REMARKS

DRAWINGS

Fig-20

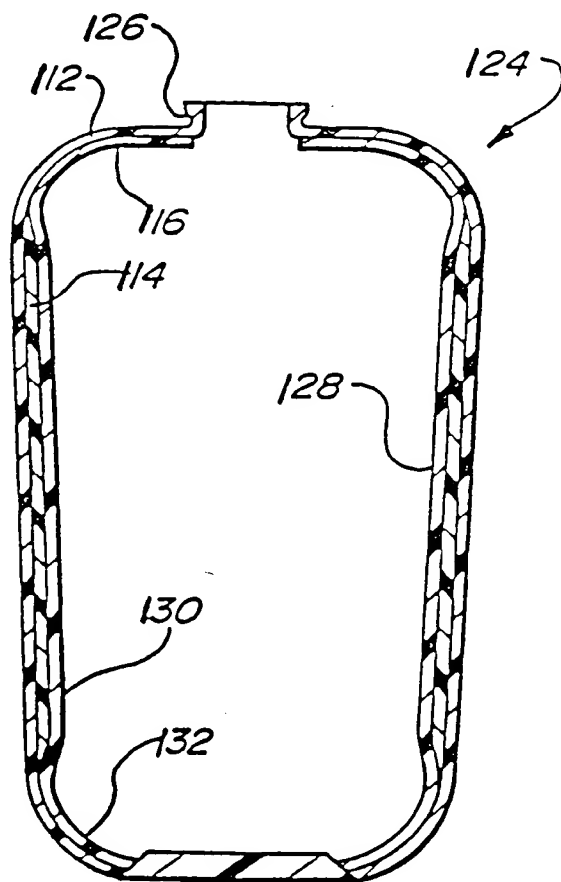
Reference signs 130 and 132 appear in Figure 20 but are not mentioned in the description. Reference sign 170 appears in Figure 21 but is not mentioned in the

description. Applicants present replacement figures in which reference signs 130, 132, and 170 have been removed.
